TITLE: Triple_Axis_Accelerometer-Gyro_Breakout_-_MPU-6050_v12

REV:

v12

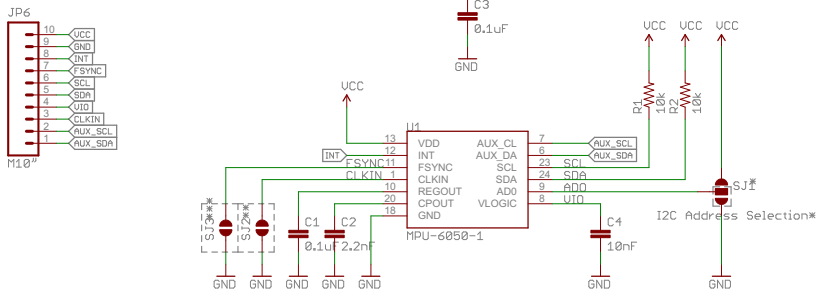
Changes to U11
 SCL and SDA were switched on U10, fixed on U11
 Broke out VLOGIC line
 C2 was mislabeled as 10nF, should have been 2.2nF.
 Added selectable jumpers to CLK, FSYNC and AD0
 Minor layout changes
 Played around with IC footprint.
 Added 4 small tcream squares to middle pad.
 Rounded and elongated pads.

BOM changes
 YES
 C2 is now 2.2nF instead of 10nF

New Stencil
 YES

Changes to U12:
